Exhibit V
Environmental Agency Correspondence

Based upon the project boundary map received on May 20, 2011 the Ohio Department of Natural Resources Division of Wildlife (DOW) has prepared these survey recommendations for Windlab's proposed Greenwich project located in Huron County.

This letter is in reference to your December 12, 2011 letter and e-mail regarding the proposed Greenwich Wind Project, proposed by WindLab Developments USA, Ltd., in Greenwich Township, Huron County, Ohio. The project involves the construction and operation of a wind farm along with associated access roads, collection lines, and associated facilities. The proposed project area appears to be primarily agricultural intermixed with forested parcels.

Figure 1. Survey effort map with the revised (May 2011) boundary for Windlab's proposed Greenwich project.

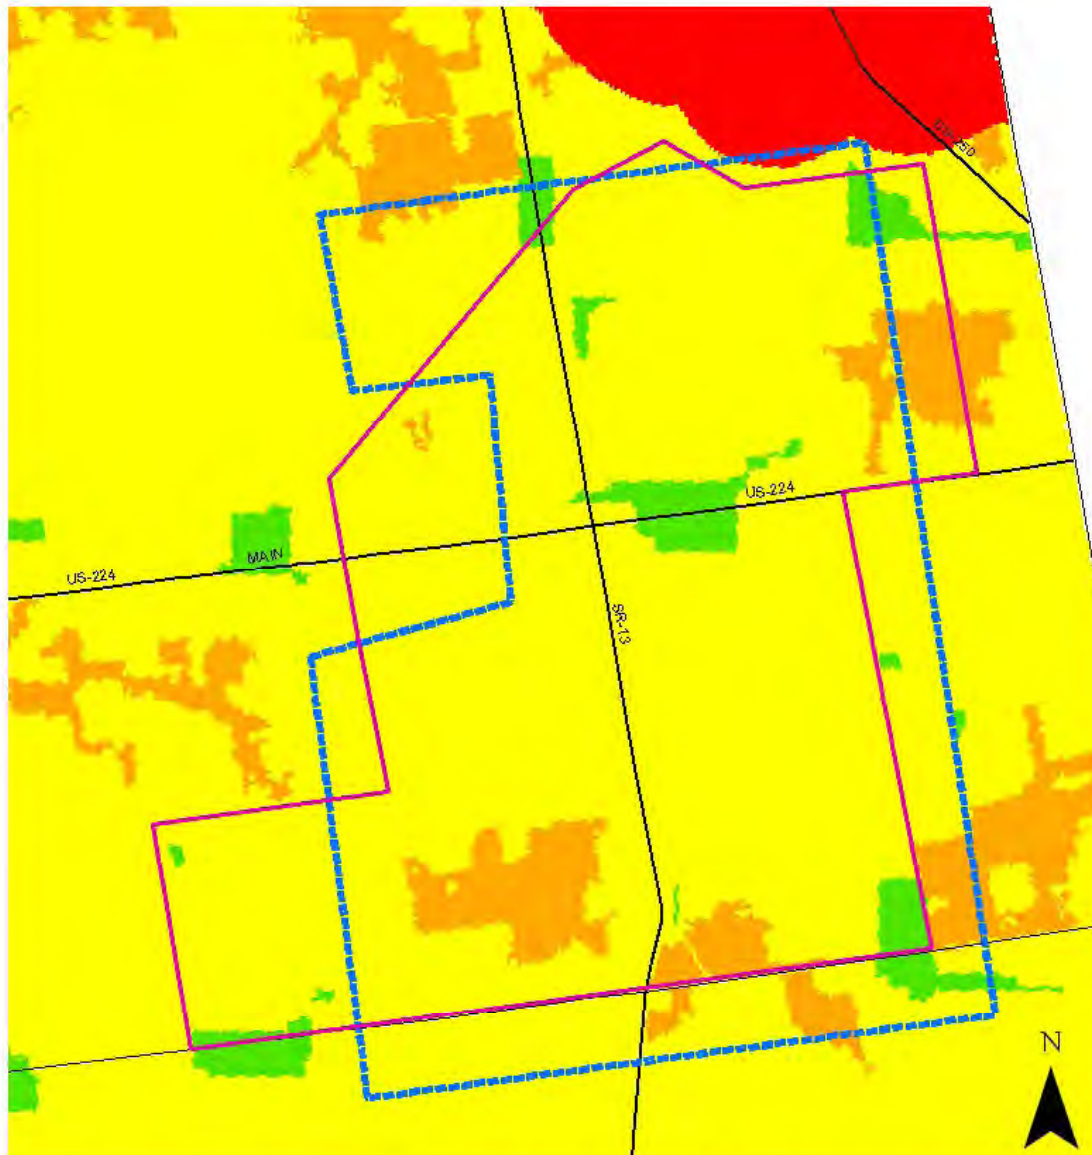
Currently the project falls within regions of the state that DOW has identified as needing moderate monitoring efforts. The below survey recommendations are based on a GIS analysis of the site and may be reevaluated after a site visit. Additionally, if the developer decides to amend the current boundaries, the DOW will revise our survey recommendations.

The table below was created based upon a review of the project maps provided and summarizes the types and level of effort recommended by the DOW. Results from these studies will help the Department of Natural Resources assess the potential impact these turbines may pose, and influence our recommendations to the Ohio Power Siting Board. Monitoring should follow those criteria listed within the "On-shore Bird and Bat Pre-Construction Monitoring Protocol for Commercial Wind Energy Facilities in Ohio."

Figure 1. Survey effort map with the revised boundary for Windlab's proposed Greenwich project.

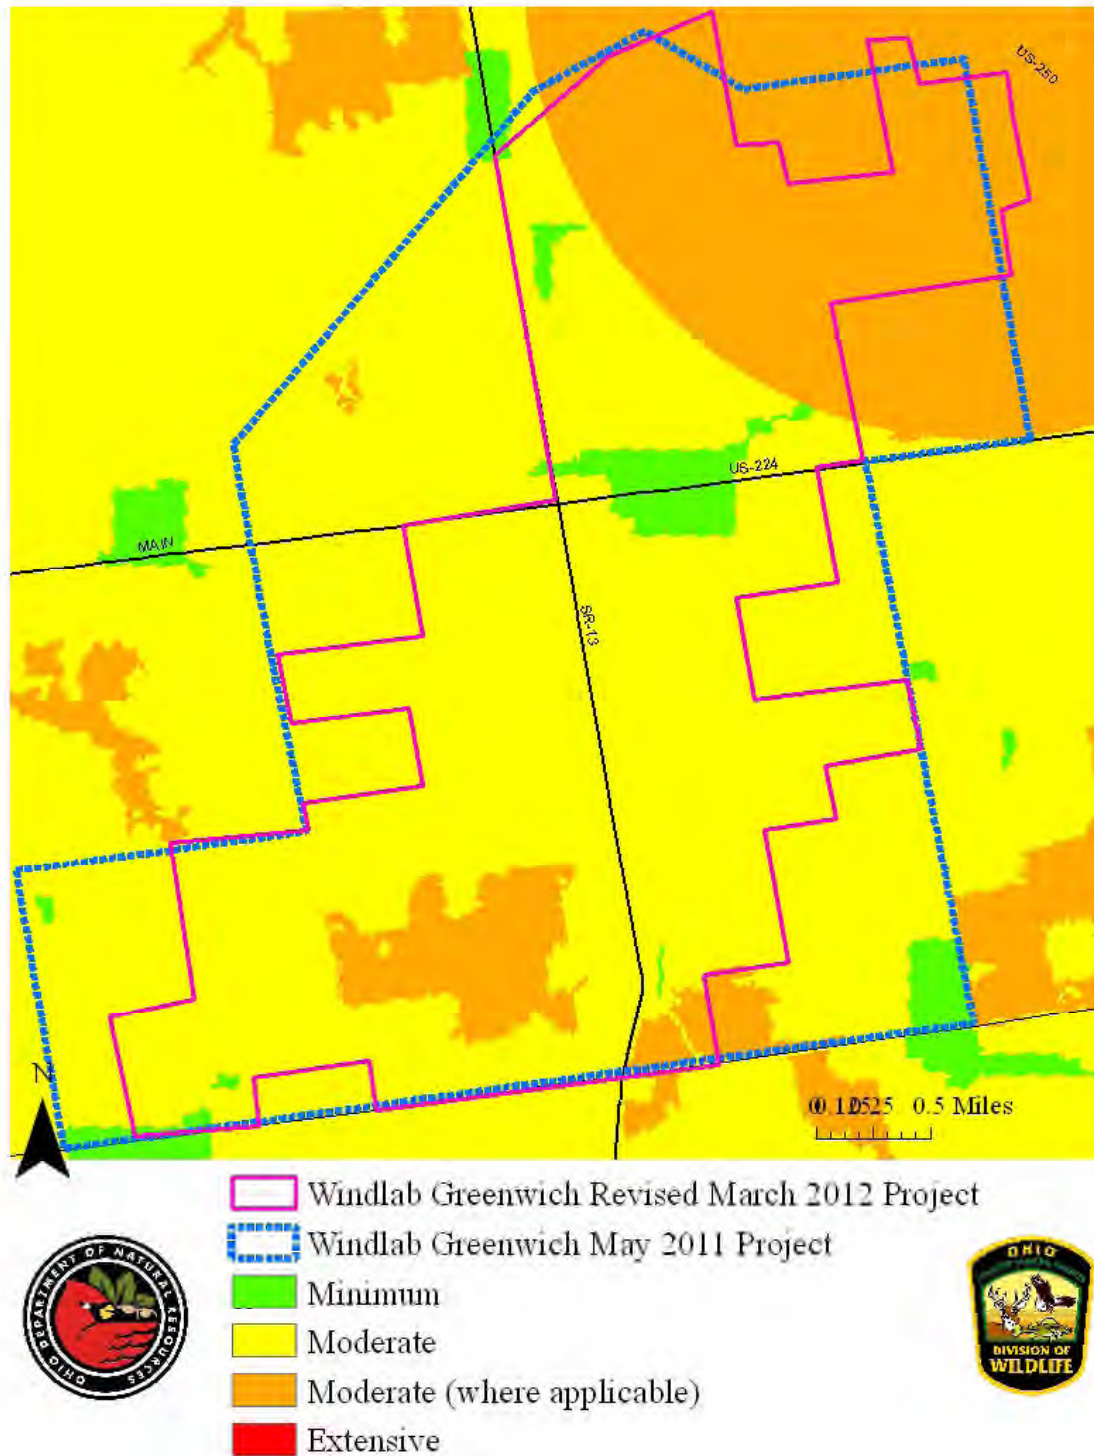
Currently the project falls within regions of the state that DOW has identified as needing moderate monitoring efforts. The below survey recommendations are based on a GIS analysis of the site and may be reevaluated after a site visit. Additionally, if the developer decides to amend the current boundaries, the DOW will revise our survey recommendations.

Raptor nest monitoring	There is 1 bald eagle nest located on or within the 2 miles of the proposed project. This pair should be monitored to assess their daily movement patterns. Should any additional nests of a protected species of raptor be located during nest searches, monitoring should commence as outlined within the on-shore protocols.
Bat acoustic monitoring	To be conducted at all meteorological towers.
Passerine migration (# of survey points)	4
Diurnal bird/raptor migration (# of survey point)	1
Sandhill crane migration (same points as raptor migration)	NS
Owl playback survey points	2
Barn owl surveys	NS
Bat mist-netting (# of survey points)	9
Nocturnal marsh bird survey points	Waived
Waterfowl survey points	NS
Shorebird migration points	NS
Radar monitoring locations	NS
